AMERICAN POWER CONVERSION

DESCRIPTION	SHEET
SB208 CIRCUIT BOARD SCHEMATIC	B

PRODUCT	APCC PART #
250/400/600 INT'L BACK-UPS	0S-208

DATE	BY	SCALE	DWG	REV
3/22/91	ESM		E208-10	10

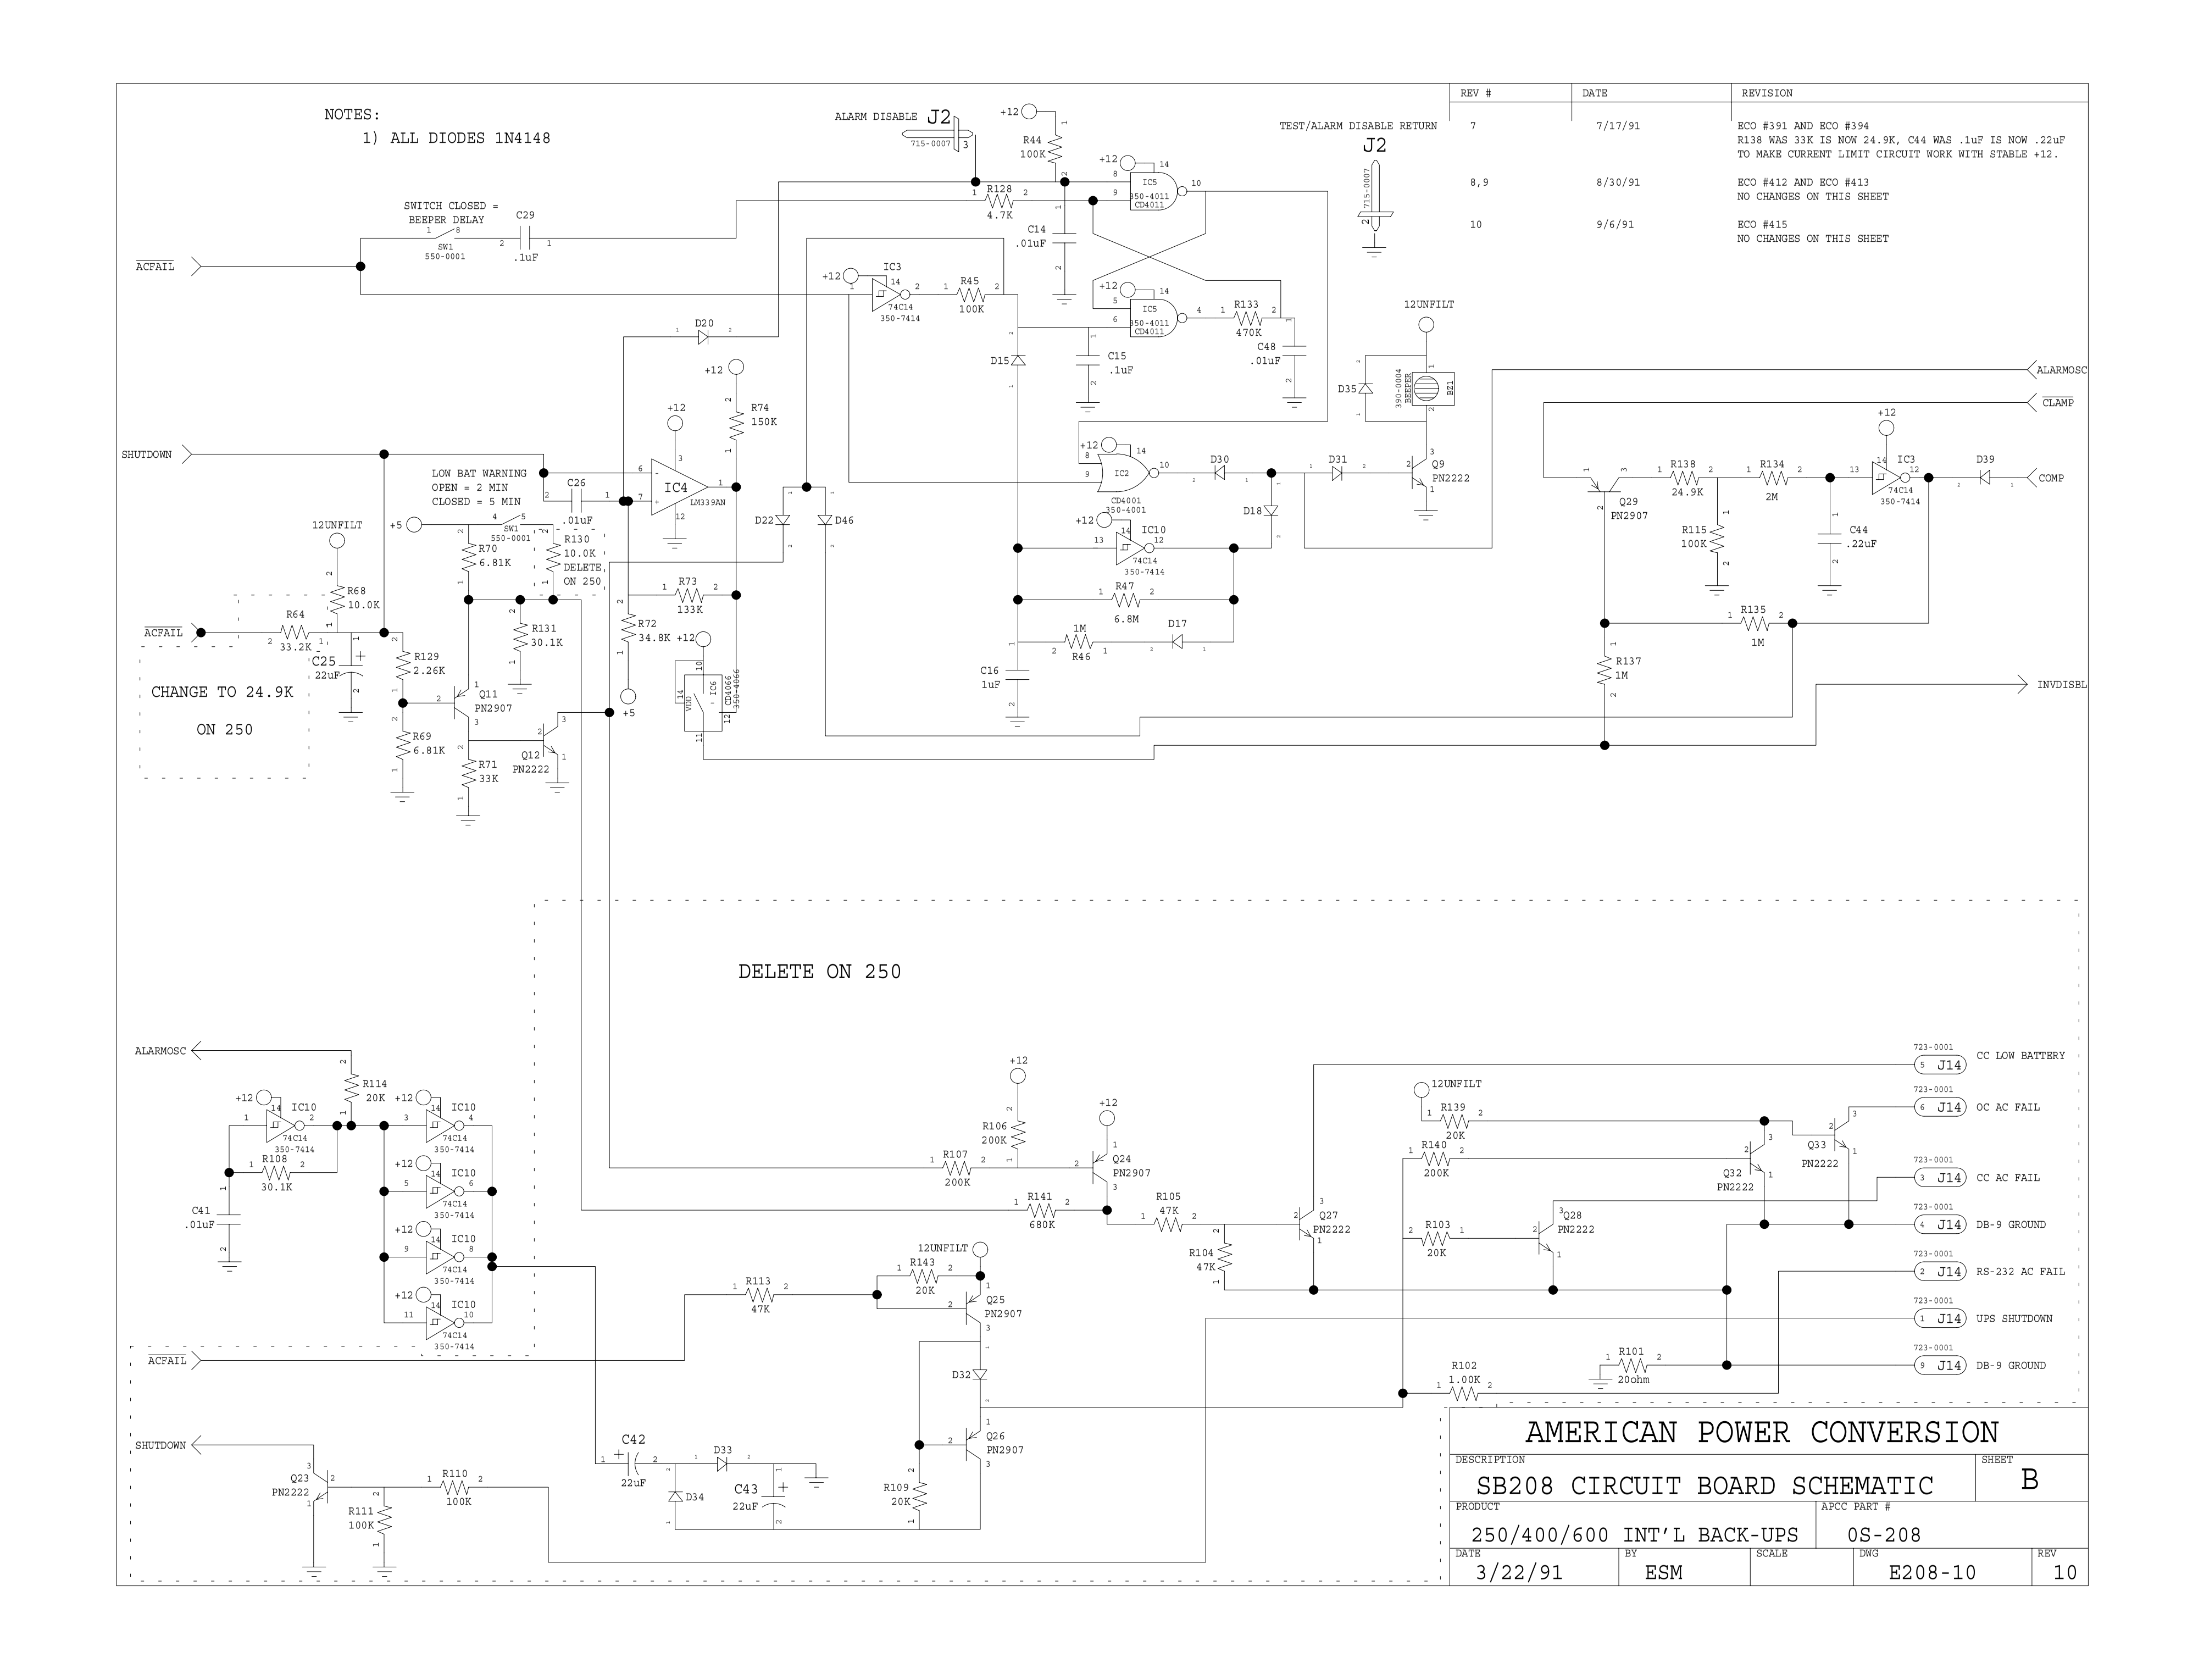
REV #	DATE	REVISION
7	7/17/91	ECO #391 AND ECO #394 R138 WAS 33K IS NOW 24.9K, C44 WAS .1uF IS NOW .22uF TO MAKE CURRENT LIMIT CIRCUIT WORK WITH STABLE +12.
8,9	8/30/91	ECO #412 AND ECO #413 NO CHANGES ON THIS SHEET
10	9/6/91	ECO #415 NO CHANGES ON THIS SHEET
